Access Compliance Report
Public Rights-of-Way
(Curb Ramps)

Intersection ID: 24904	**Main Street:** PROVIDENCE_RD	**Cross Street:** PINEVILLE-MATTHEWS_RD	**Location:** NW
ADA ID: A44988EE5698	**Ramp Type:** IslandPerp	**Initial Pass/Fail:** Fail **Overall Compliance:** No	**Severity Score:** 8.75

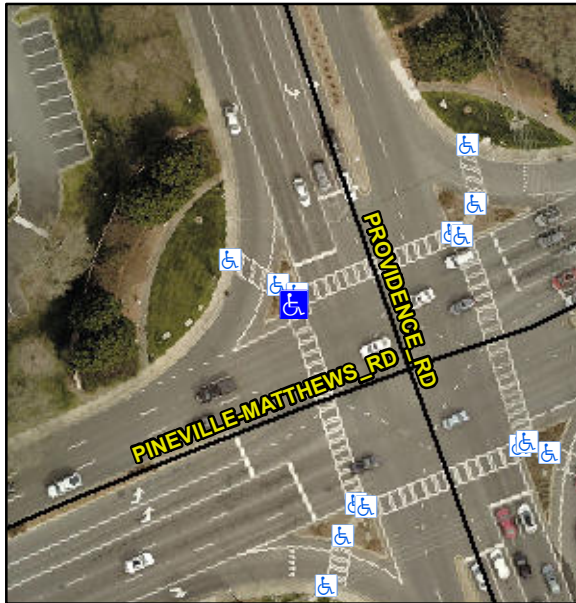
Not Found, R304.5.1

Compliance	**Description**	**Data**	**Compliance**	**Description**	**Data**
N/A	Ramp Length (in)	24.0	Yes	Ramp Slope (%)	7.0
No	Ramp Width (in)	37.0	Yes	Ramp XSlope (%)	2.0
N/A	Flare Type LT	N/A	N/A	Flare Type RT	N/A
N/A	Flare Slope LT (%)	N/A	N/A	Flare Slope RT (%)	N/A
N/A	Flare Traversable LT?	N/A	N/A	Flare Traversable RT?	N/A
N/A	Landing Length (in)	N/A	N/A	DWS Provided?	N/A
N/A	Landing Width (in)	N/A	N/A	DWS Contrast?	N/A
N/A	Landing Slope (%)	N/A	N/A	DWS Length (in)	N/A
N/A	Landing X Slope (%)	N/A	N/A	DWS Full Width?	N/A
N/A	Landing Curb? (Y/N)	N/A	N/A	DWS Offset (in)	N/A
N/A	Shared Landing?	N/A			
N/A	Gutter Ponding?	N/A	N/A	Gutter Slope (%)	N/A
N/A	Gutter Lip Ht (in)	N/A	N/A	Gutter X Slope (%)	N/A
N/A	Painted X Walk1?	Yes	N/A	Painted X Walk2?	N/A
	X Walk 1 Direction	To S		X Walk 2 Direction	N/A
N/A	X Walk 1 Width (in)	101.0	N/A	X Walk 2 Width (in)	N/A
	X Walk 1 Slope (%)	1.2		X Walk 2 Slope (%)	N/A

Remove & Replace Entire Ramp.
